SUNDRY NOTICES AND REPORTS ON WELLS
Do not use this form for proposals to drill or to re-enter an abandoned well. Use form 3160-3 (APD) for such proposals.

5	Lease Serial No
	NM-052
6	If Indian, Allottee or Tribe Name
7	If Unit or CA/Agreement, Name and/or No.
8	Well Name and No
	Mallon 34 Federal Com No. 18
9	API Well No
	30-025-39763
10	Field and Pool, or Exploratory Area
	Quail Ridge; Bone Spring, South
11	County or Parish, State
	Lea County, NM

Cimarex is switching to a 5000 psi BOP tested to 3000 psi as shown below to drill the Mallon 34 Fed Com 18. Also see attached BOP/Choke plats.

Exhibit E – 5000# BOP tested to 3000#
Mallon 34 Federal Com No. 18
Cimarex Energy Co. of Colorado
34-19S-34E
SHL 640 FSL & 300 FWL
BHL 330 FSL & 330 FEL
Lea County, NM

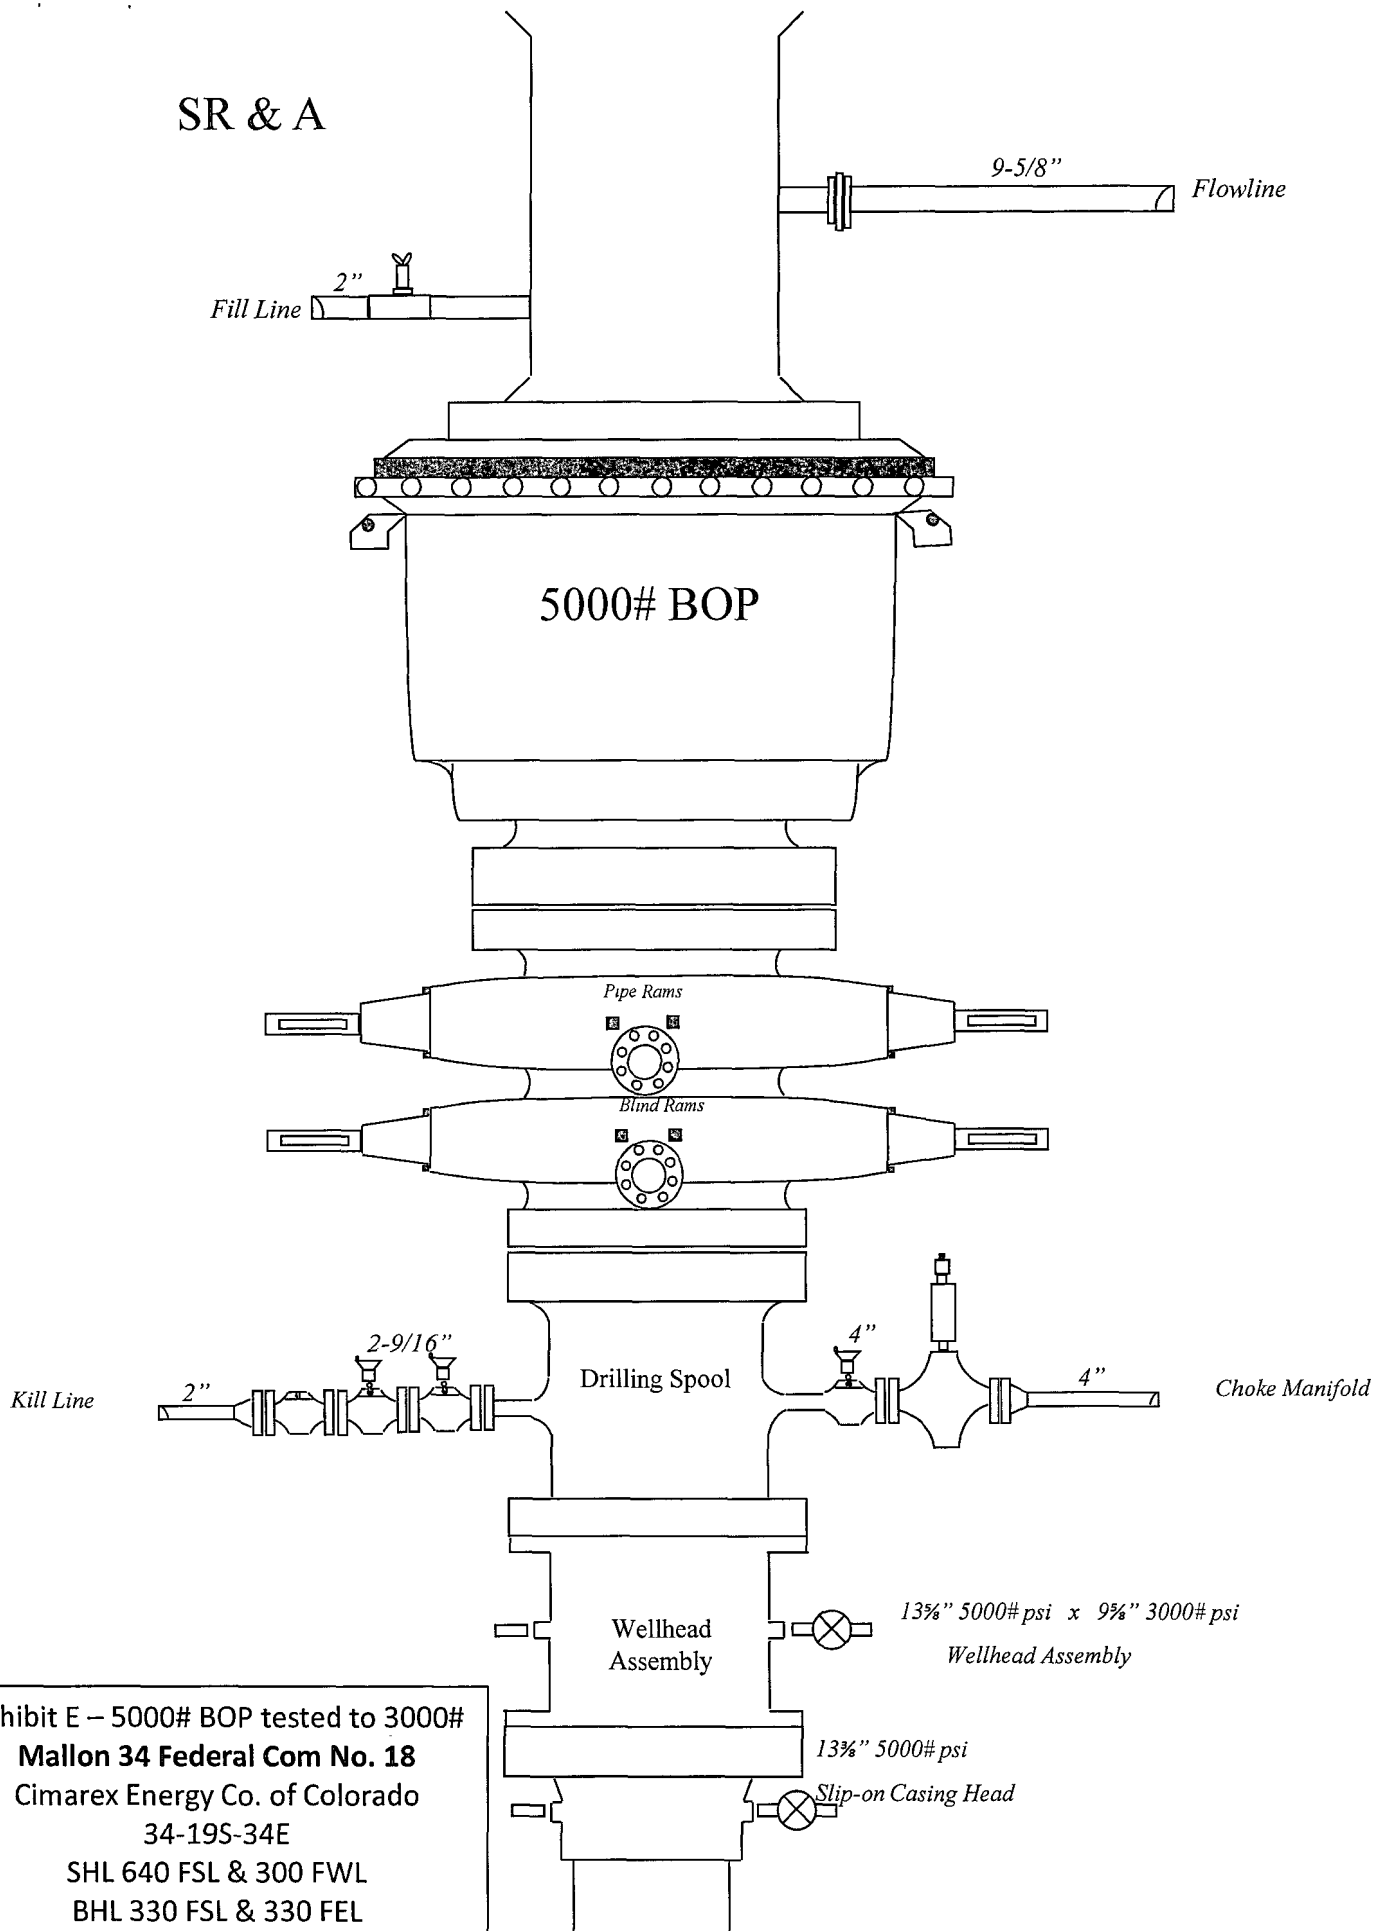
Exhibit "E". A 13%" 5000 PSI working pressure BOP tested to 3000 psi consisting of one set of blind rams and one set of pipe rams and a 5000# annular type preventer. A choke manifold and 120 gallon accumulator with floor and remote operating stations and auxiliary power system. Rotating head as needed. A kelly cock will be installed and maintained in operable condition and a drill string safety valve in the open position will be available on the rig floor.

BOP unit will be hydraulically operated. BOP will be nipped up and operated at least once a day while drilling and the blind rams will be operated when out of hole during trips. No abnormal pressure or temperature is expected while drilling. From the base of the 13%" casing through the running of production casing, the well will be equipped with a 5000 psi BOP system tested to 3000 psi.

BOPS will be tested by an independent service company to 250 psi low and 3000 psi high. Hydril will be tested to 250 psi low and 1500 psi high.

1. All blowout preventer (BOP) and related equipment (BOPE) shall comply with well control requirements as described in Onshore Oil and Gas Order No. 2 and API RP 53 Sec. 17.

2. Minimum working pressure of the blowout preventer (BOP) and related equipment (BOPE) required for drilling below the surface casing shoe shall be **3000 (3M) psi.**

- e. The BOP/BOPE test shall include a low pressure test from 250 to 300 psi. The test will be held for a minimum of 10 minutes if test is done with a test plug and 30 minutes without a test plug.

Exhibit E-1 – Choke Manifold Diagram

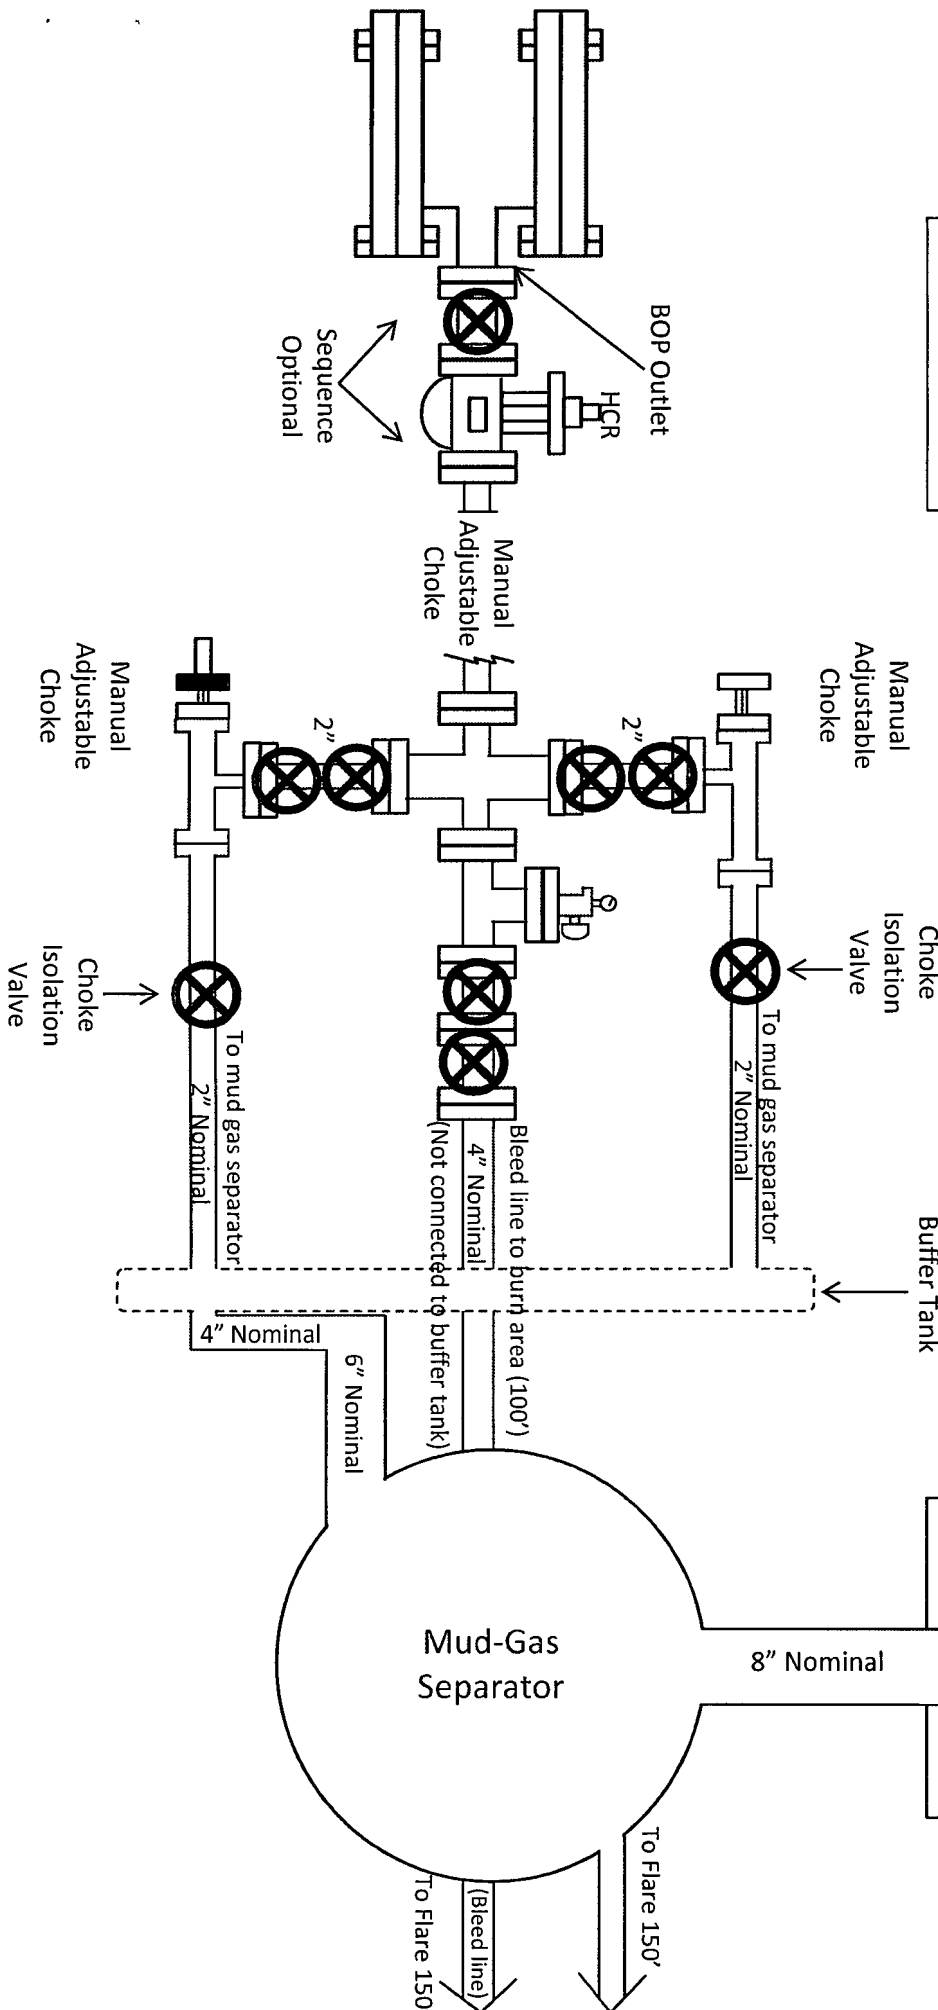
Drilling Operations Choke Manifold 5M Service tested to 3M
